Department of Transportation

MEMORANDUM

SUBJECT: ZC Case No. 25-07 – Bridge District Parcel 5

Figure 1 | Site Plan

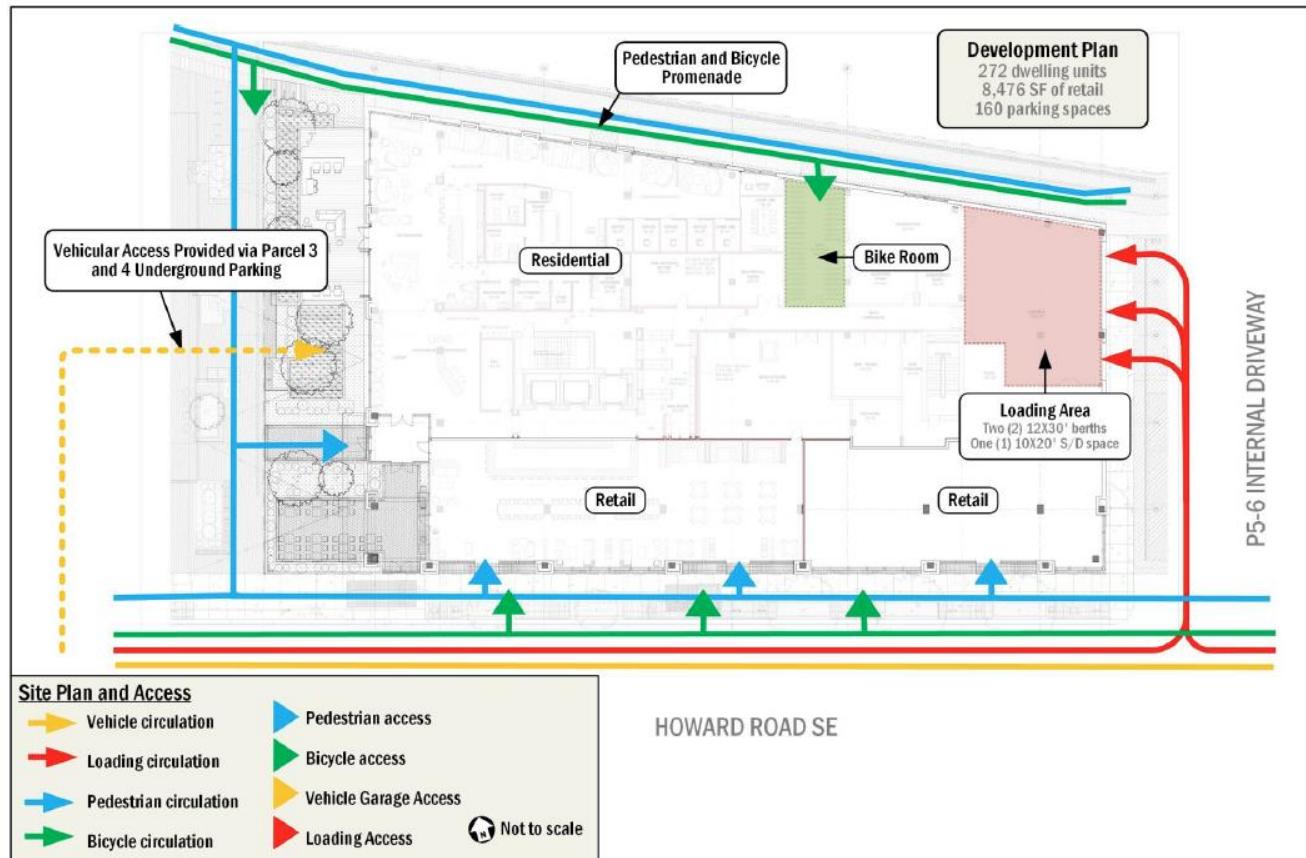
While the preliminary public space plans, shown above in Figure 1, are generally consistent with DDOT standards, there are several considerations that need to be reviewed in greater detail during the public space permitting process:

- Coordinate with DDOT's Traffic Safety Administration through the public space permitting process on the design of the raised crosswalk across Howard Road;
- Submit a detailed curbside management plan with proposed signage for review and approval by DDOT Curbside Management Division (CMD). If CMD requires multi-space meters for the remainder of the frontage, they will be at the Applicant's expense;
- Provide a plan showing the detailed design of the long-term bike storage room so PSD can confirm it meets the requirements in Title 11 of DCMR, Subtitle C § 800, Title 18 of DCMR, § 1214, and DDOT *Bike Parking Guide* best practices, including larger cargo/tandem spaces; and
- Any future outdoor café patios within public space will require a public space occupancy permit.

Figure 4 | Future Pedestrian Network

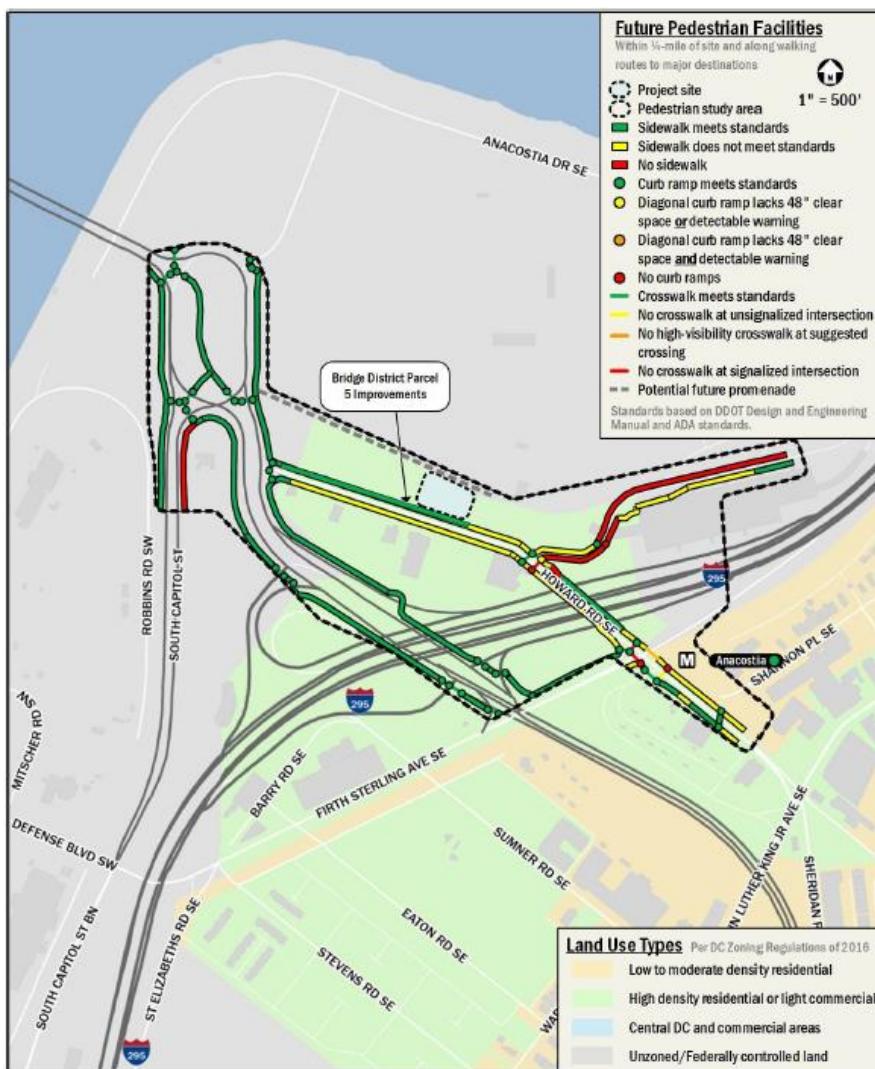
The CTR's inventory of existing pedestrian infrastructure, as shown in Figure 4 below, demonstrates that many sidewalks in the immediate vicinity of the site are currently constructed with appropriate widths and include accessible curb ramps. While there are several missing or substandard facilities in the broader area, the existing pedestrian network along major walking routes from the site to attractions and the Metrorail station is generally adequate.

Figure 6 | Proposed Curbside Designations

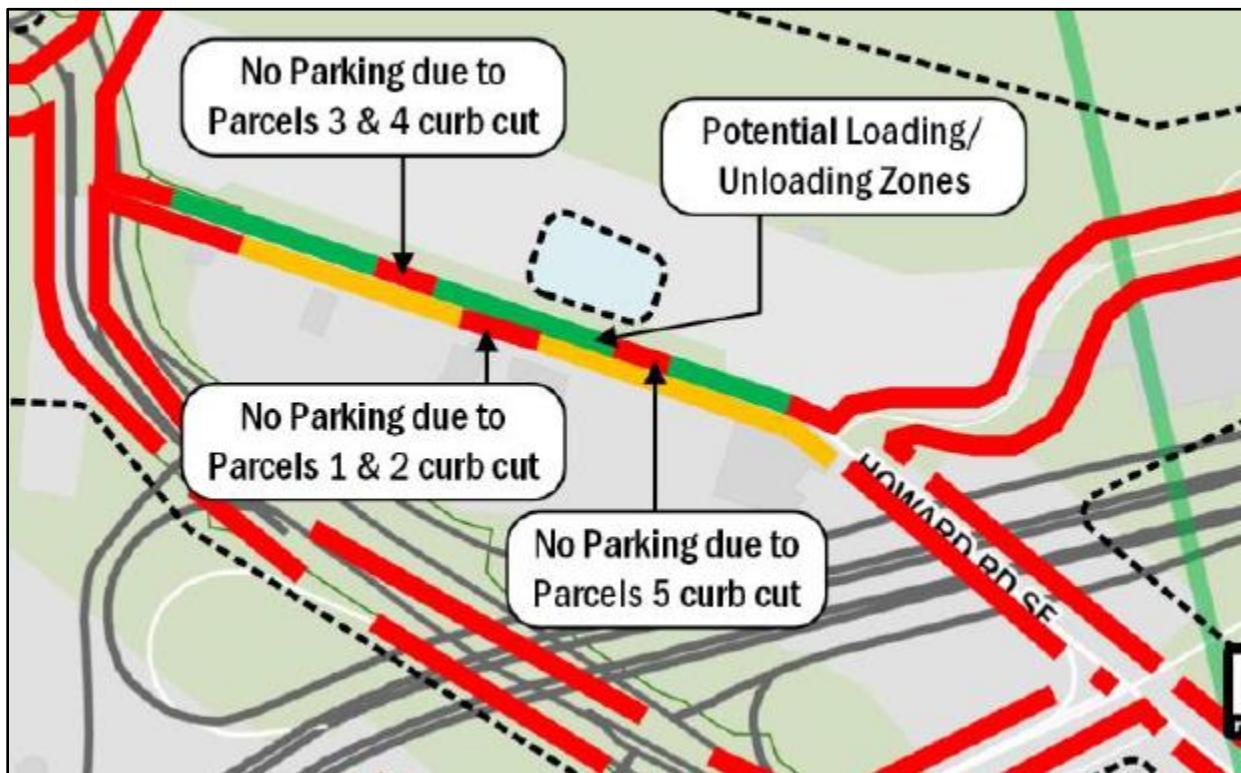
The site currently has metered parking along the Howard Road frontage. As shown below in Figure 6, the Applicant is exploring the possibility of a passenger loading zone near the retail entrance. DDOT is generally supportive of this concept; however, a detailed curbside and signage plan must be submitted during public space permitting for review and approval by DDOT's Curbside Management Division (CMD). At that time, the plan may be refined by CMD and the exact signage placards will be determined. If multi-space meters are required by CMD then they will be at the Applicant's expense.
